Mechanical Addendum M-001

Date: June 19, 2026
Project: Ontario Aboriginal Housing Services
Location: 321 John Street, Cobourg, Ontario
IVES Project: 22071

M-401A

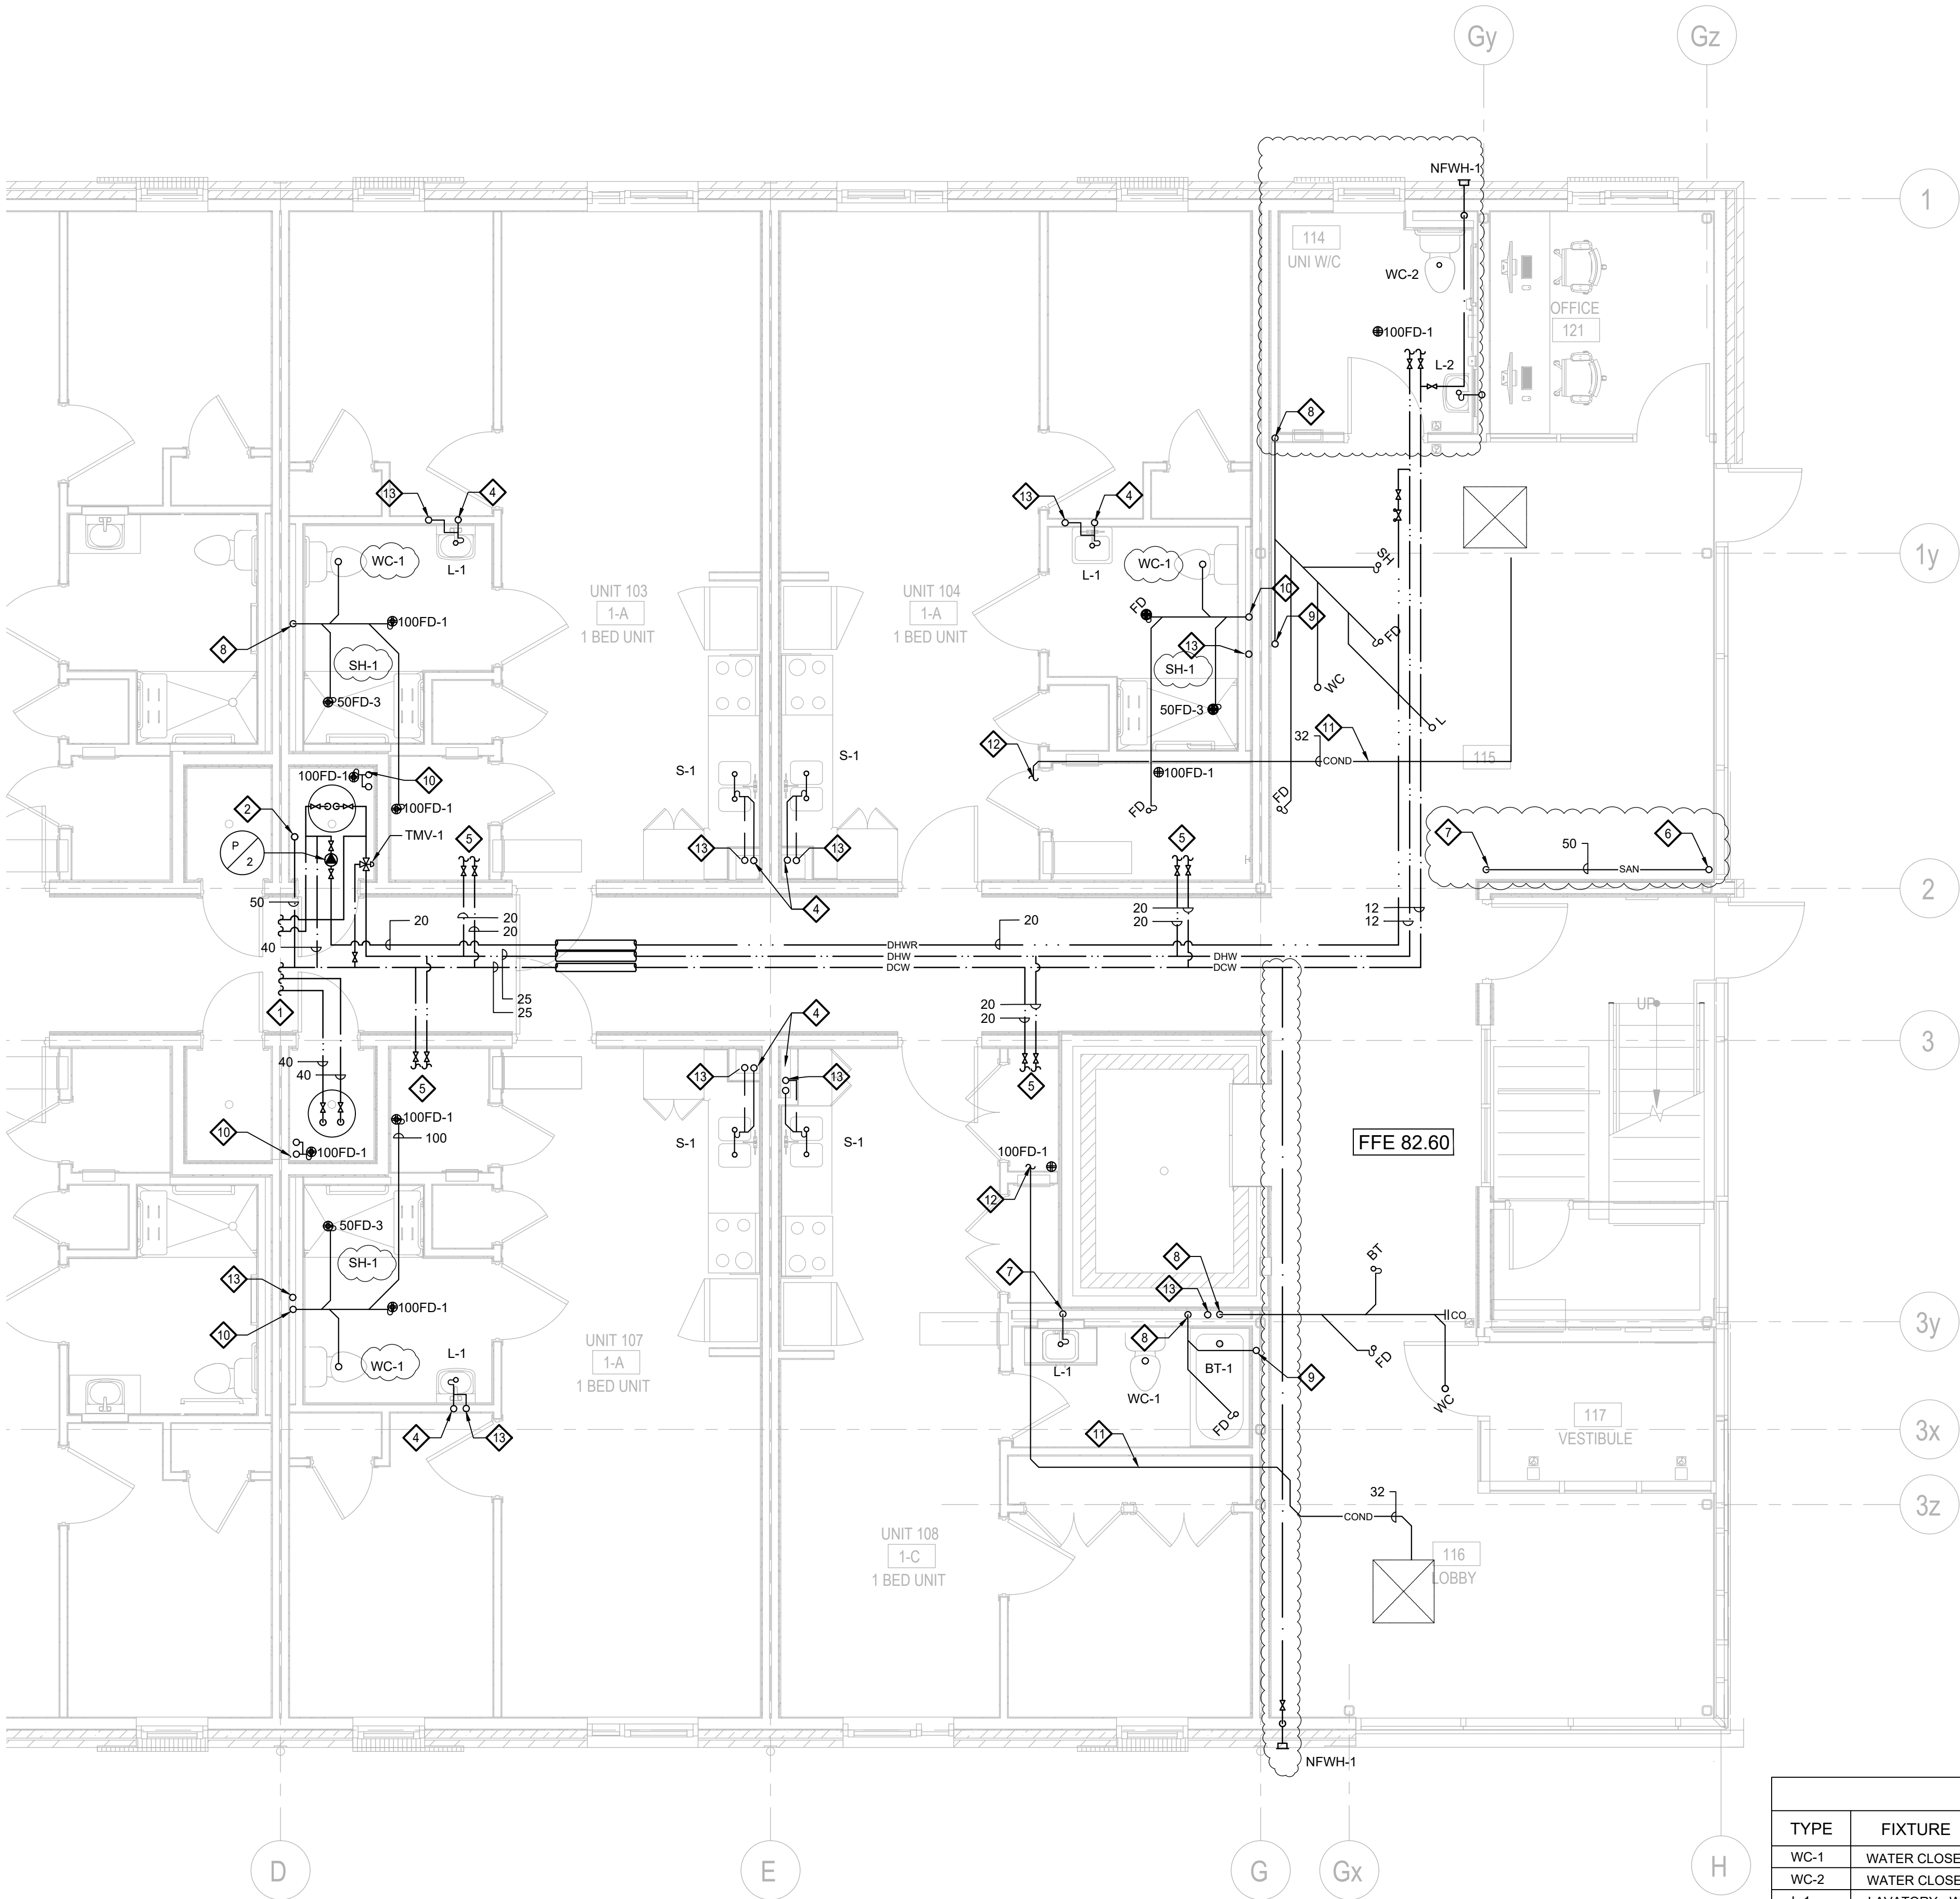
- 1.17.1. Revised as indicated.
- 1.18. Refer to Mechanical Drawing M-401A – Ground Floor West Plumbing Plan (Re-issued)
 - 1.18.1. Revised as indicated.

M-401B

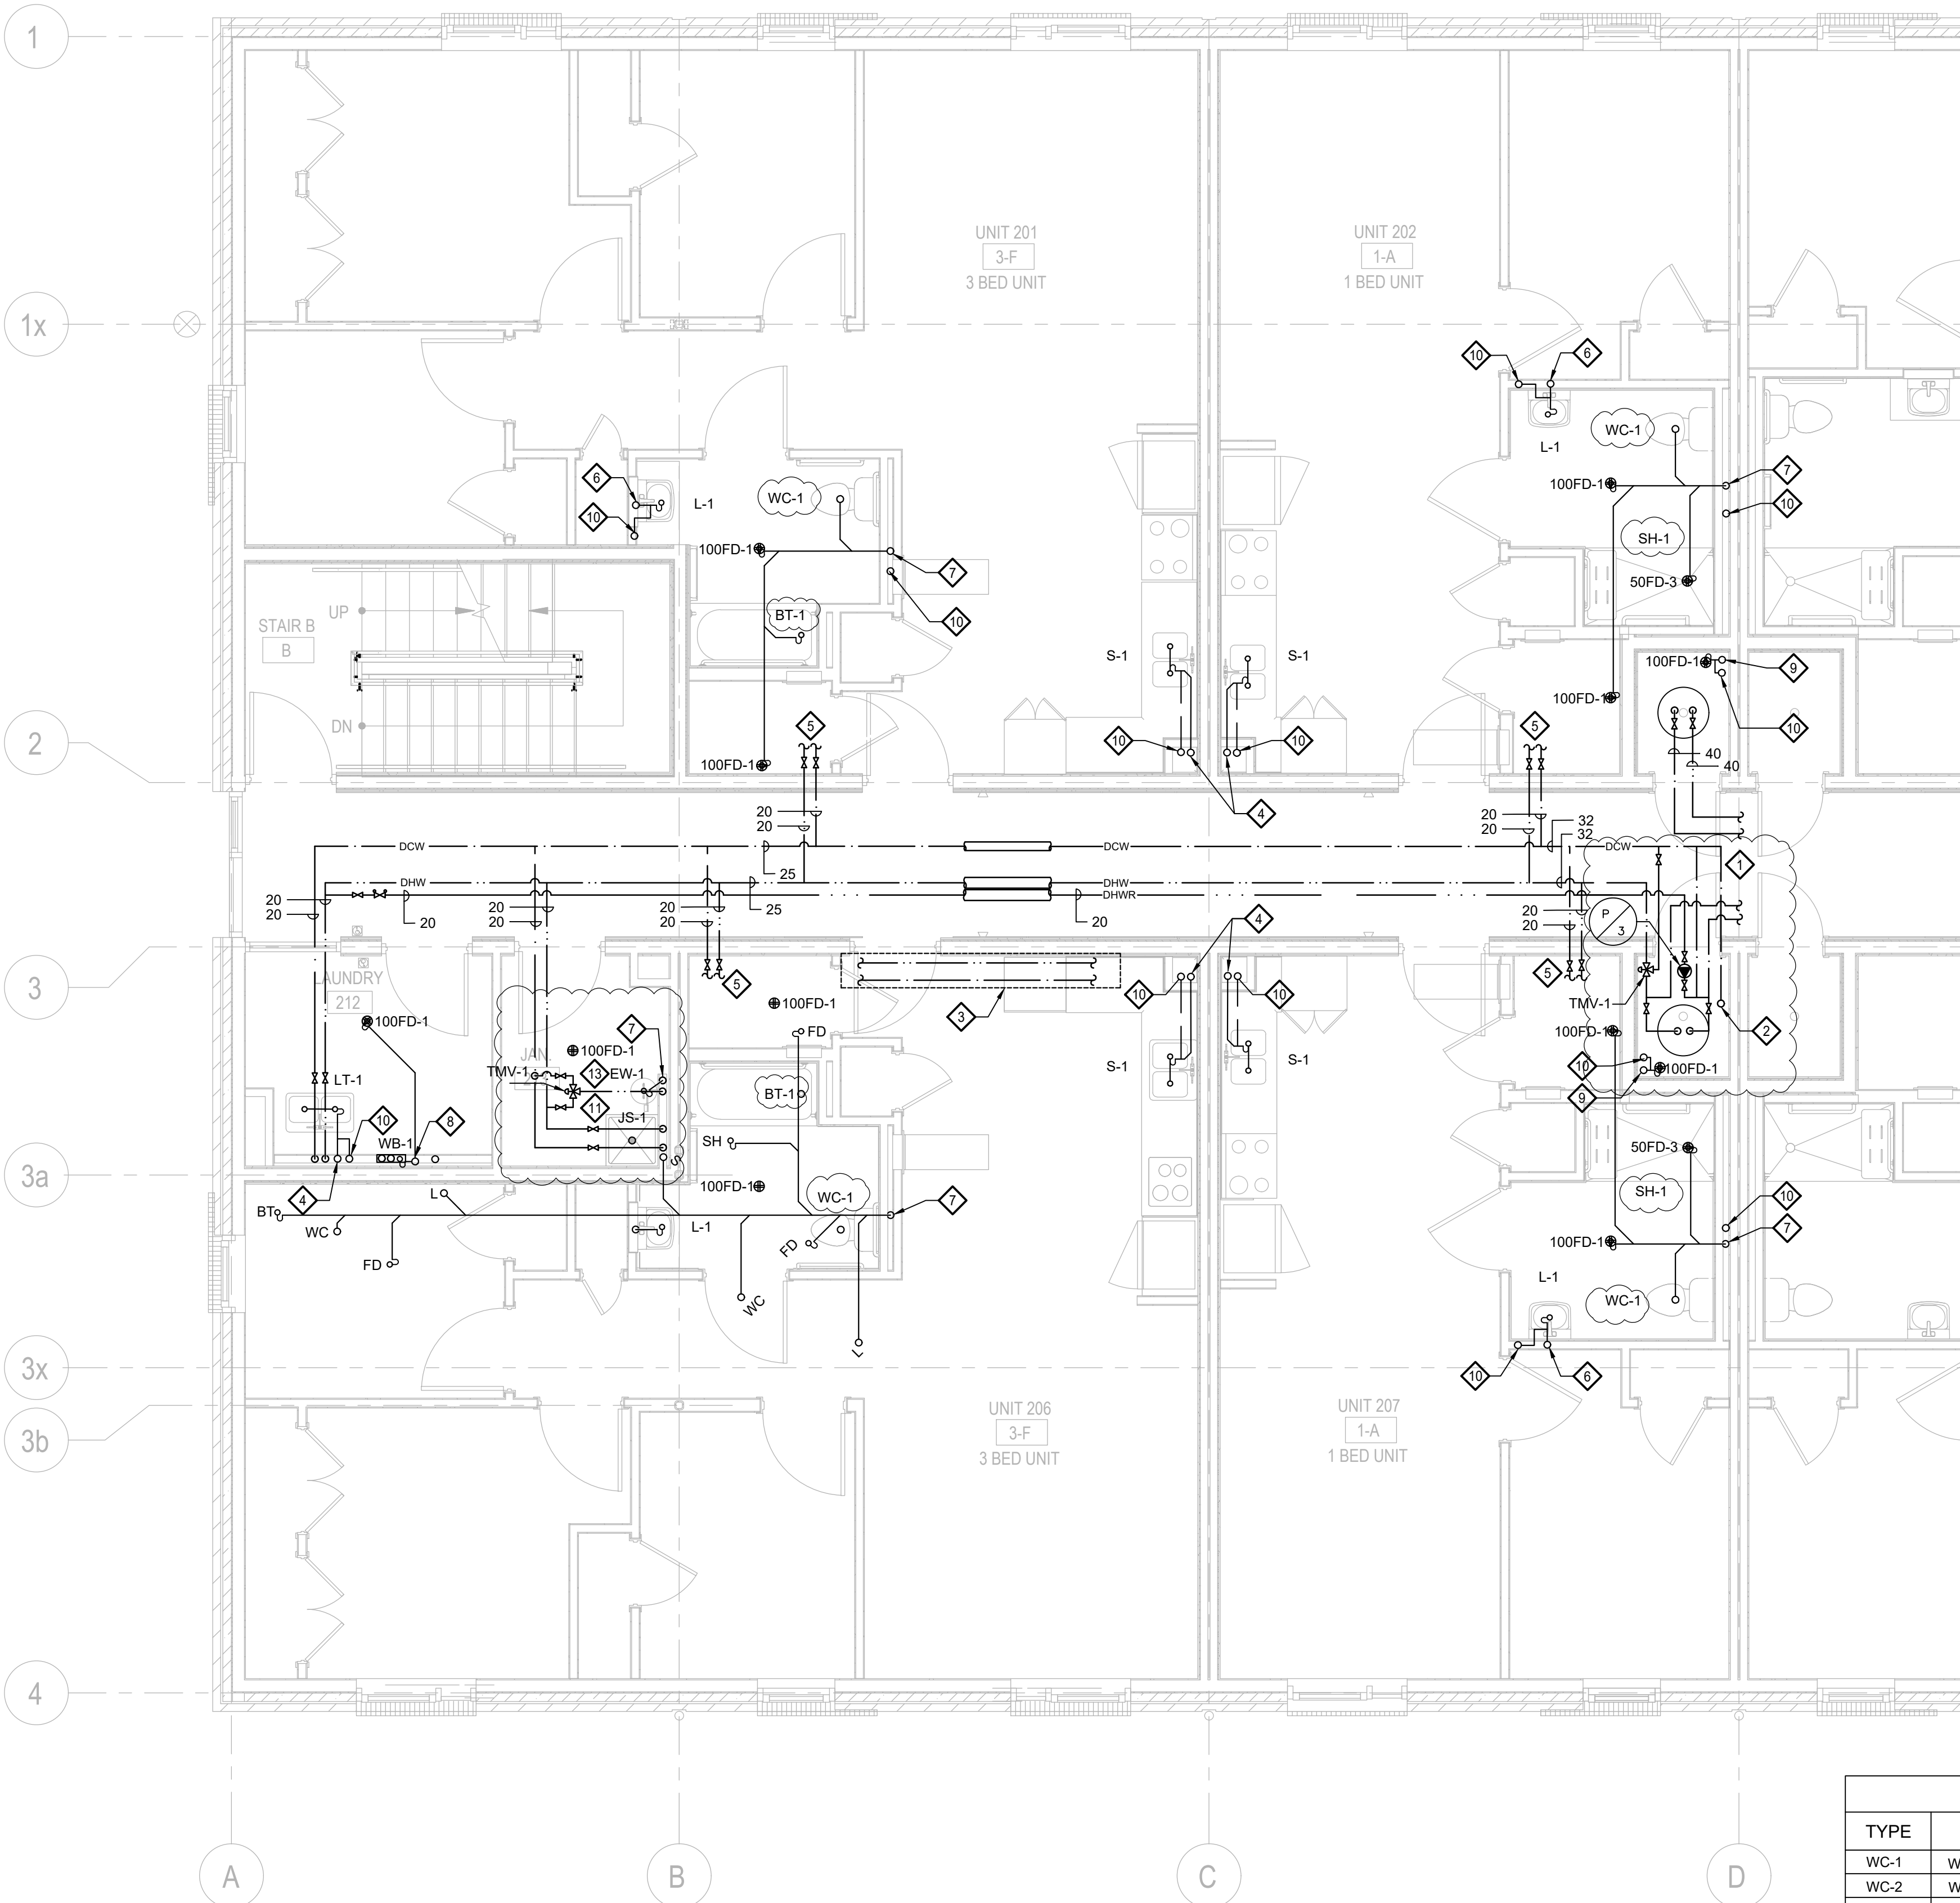
- 1.19. Refer to Mechanical Drawing M-401B – Ground Floor East Plumbing Plan (Re-issued)
 - 1.19.1. Revised as indicated.
- 1.20. Refer to Mechanical Drawing M-402A – Second Floor West Plumbing Plan (Re-issued)

M-402B

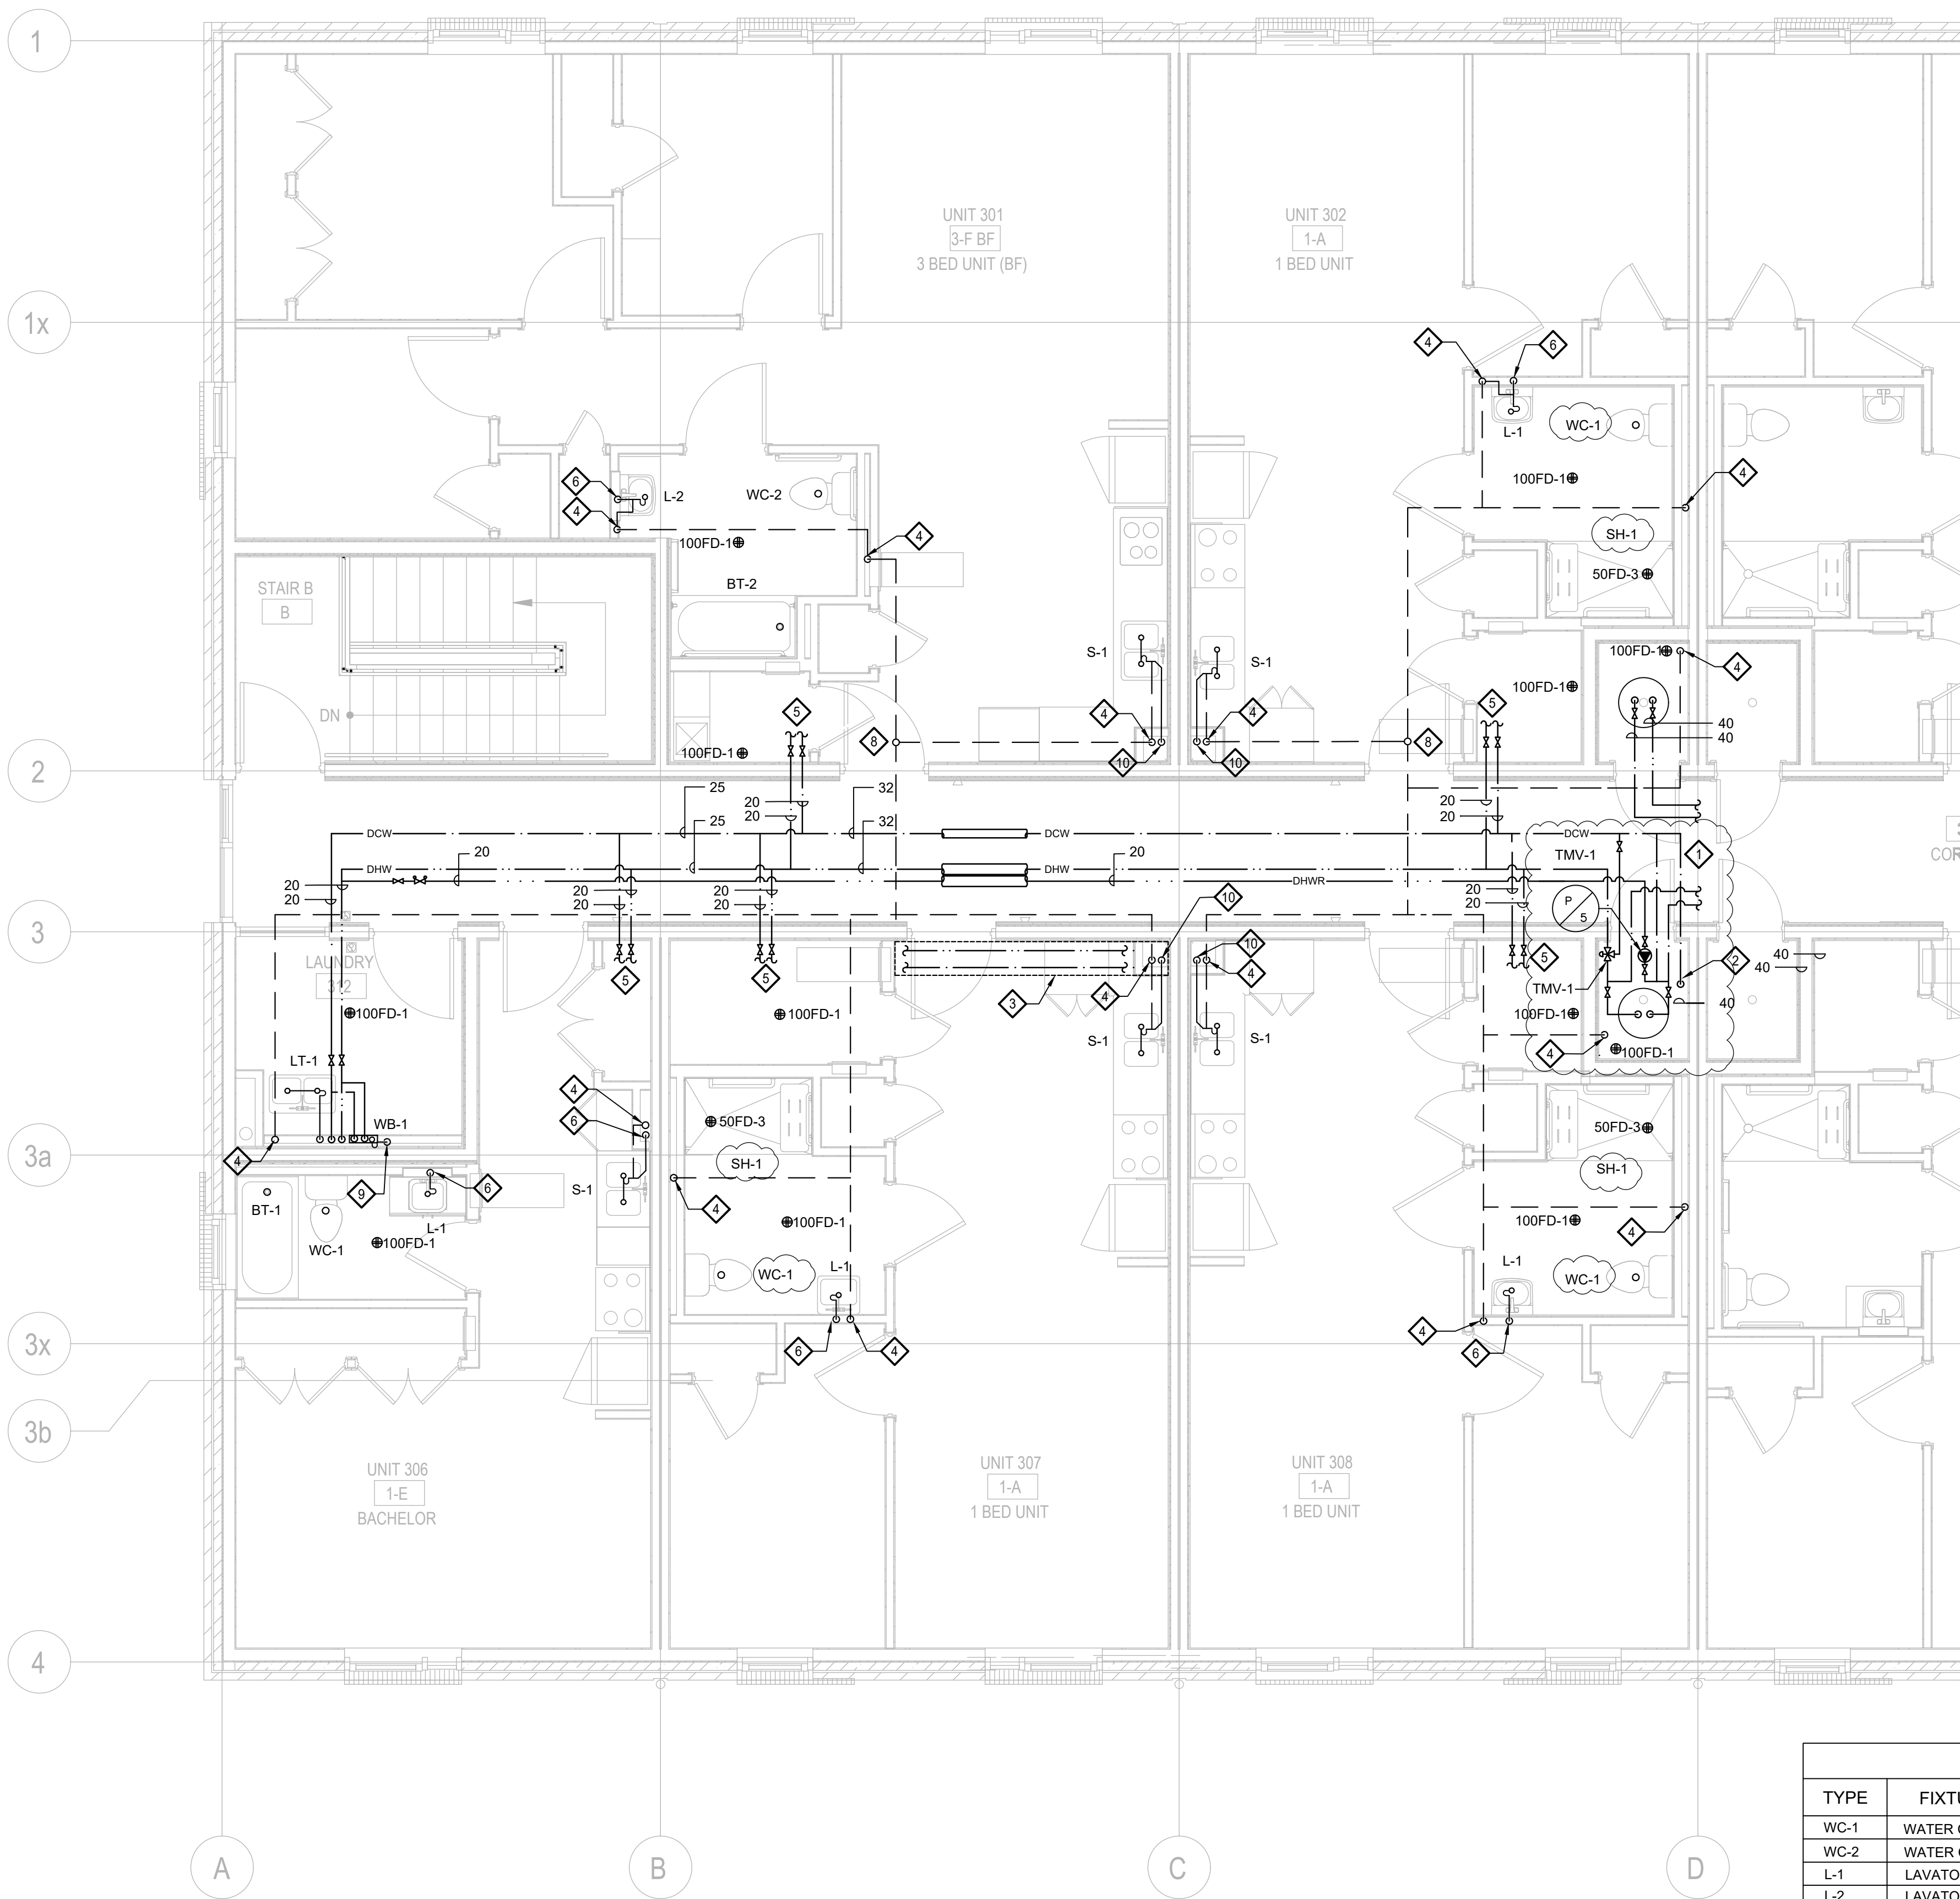
- 1.20.1. Revised as indicated.
- 1.21. Refer to Mechanical Drawing M-402B – Second Floor East Plumbing Plan (Re-issued)
 - 1.21.1. Revised as indicated.
